Form 3160-5 (August 2007)

UNITED STATES DEPARTMENT OF THE INTERIOR BUREAU OF LAND MANAGEMENT

McIntyre A East #15

Mcintyre A East 15 30-015-31854 COG Operating, LLC. January 29, 2015 Conditions of Approval

Lease & Well # McIntyre A East #15

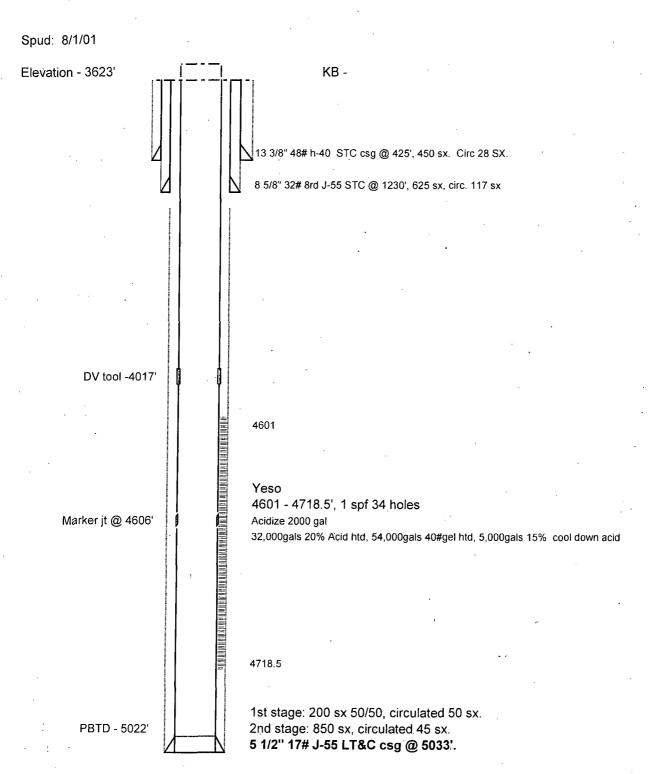
1. Operator shall set a CIBP at 4,551' and place 40' Class C cement on top. Tag required.

Note: At a later date, the Glorieta formation and the DV tool must be abandoned properly.

- 2. Must conduct a casing integrity test before perforating and fracturing. Submit results to BLM. The CIT is to be performed on the production casing to max treating pressure. Notify BLM if test fails.
